UNITED STATES PATENT AND TRADEMARK OFFICE

10/568,084

Office Action Summary	Application No. 10/568,084	Applicant(s) HAAF, DIETRICH	
	Examiner MICHAEL CALABRESE	Art Unit 3637

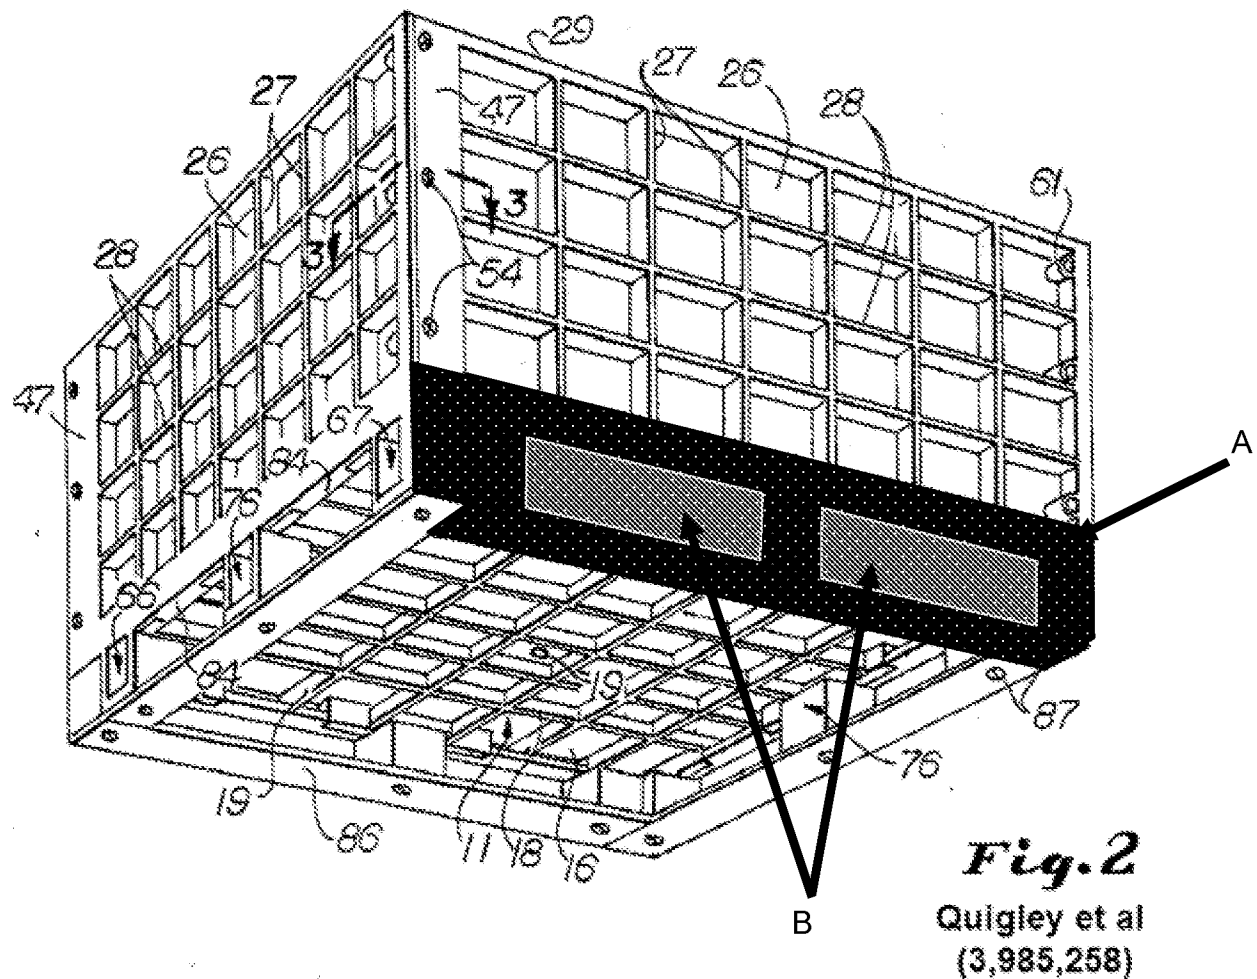
(12) (See Figures 1-2). Roper does not explicitly state said side walls of legs having at least one opening capable of receiving each prong of a stacker. Quigley is cited for teaching side walls of legs (A; See marked up Figure 2 below) having at least one opening (B; See marked up Figure 2 below) capable of receiving each prong of a stacker or fork-lift. It would have been obvious to a person having ordinary skill in the art at the time of the invention to modify the load support of Roper so as to include openings in the sidewalls of the legs capable of receiving each prong of a stacker or fork-lift as taught by Quigley in order to allow for the load support to be carried by a machine when it supports a large load. The limitations, "a stacker having prongs" and "for each prong of the stacker" (lines 8-9) are interpreted in this instance as intended use language. The corresponding structure need not perform the intended functions, but rather, be capable of performing the intended use. In this case, with the teaching of Quigley, Roper's load support is obviously capable of receiving a prong of a fork lift or stacker.

prong of a fork-lift or of a lifting truck (stacker). Quigley is cited for teaching said openings (B; See marked up Figure 2 above) are capable of being wider than a prong of a fork-lift or of a lifting truck (stacker) and said openings (B; See marked up Figure 2 above) are capable of being higher than a prong of a fork-lift or of a lifting truck (stacker). Quigley teaches in Col. 4, Lines 15-20, that the forks of a fork-lift are inserted into the openings (B; See marked up Figure 2 above), thus obviously necessitating the width and height of the openings to be larger than any respective width and height of fork-lift forks. It would have been obvious to a person having ordinary skill in the art at the time of the invention to modify the load support of Roper so as to include the openings adapted to be wider than the prong of a fork-lift or of a lifting truck and adapted to be higher than the prong of the fork-lift or of the lifting truck as taught by Quigley in order to allow for entrance of the forks into the openings in order to lift the load support. It follows that for the purpose of this examination and the position taken, the limitations, adapted to be higher and wider than the prong of the stacker are interpreted in this instance as intended use language. The corresponding structure need not perform the intended functions, but rather, be capable of performing the intended use. In this case, with the teaching of Quigley, Roper's load support obviously has openings capable of being wider and higher than a prong of a fork lift or stacker.

19. As for Claim 25, Roper does not explicitly state two parallel openings are provided. Quigley is cited for teaching two parallel openings (B; See marked up Figure 2 above) being provided. It would have been obvious to a person having ordinary skill in the art at the time of the invention to modify the load support of Roper so as to

20. As for Claim 26, Roper does not explicitly state a separation between center axes of said openings is between 340 mm and 400 mm or about 370 mm. Quigley is cited for teaching a load support device having spaced-apart openings wherein there is a separation between the center axes of the openings (B; See marked up Figure 2 above). Quigley, however, is silent as to the dimensions of the spacing. It would have been an obvious matter of design choice to form the openings with a separation between center axes of said openings being between 340 mm and 400 mm or about 370 mm, since such a modification would have involved a mere change in the size of a component. A change in size is generally recognized as being within the level of ordinary skill in the art. *In re Rose*, 105 USPQ 237, (CCPA 1955). Therefore, it would have been obvious at the time of the invention to modify the spacing of the openings of the load support device of the Roper and Quigley combination to the range of 240-400 mm, or about 370 mm, to conform to the desired spacing of the fork-lift forks to be used to lift the load support as this is an obvious design choice well within the skill of an ordinary craftsman.

21. As for Claim 27, Roper does not explicitly state a height of said openings is more than 85 mm and a width of said openings is greater than 260 mm. Quigley is cited for teaching openings (B; See marked up Figure 2 above) in the legs (A; See marked up Figure 2 above) of the load support. Quigley, however, is silent as to the height and

22. As for Claim 28, Roper and Quigley do not explicitly state the dimensions of said openings correspond to standardized dimensions of transport pallets. It would have been obvious to a person having ordinary skill in the art at the time of the invention to modify the openings (B; See marked up Figure 2 above) so as to form them with dimensions corresponding to standardized dimensions of transport pallets as a change in size is generally recognized as being within the level of ordinary skill in the art. *In re Rose*, 105 USPQ 237, (CCPA 1955). Furthermore, it would have been obvious at the time of the invention to modify dimensions of the openings to conform to the dimensions of the fork-lift forks to be used to lift the load support as this is an obvious design choice that is well within the level of skill of an ordinary craftsman.
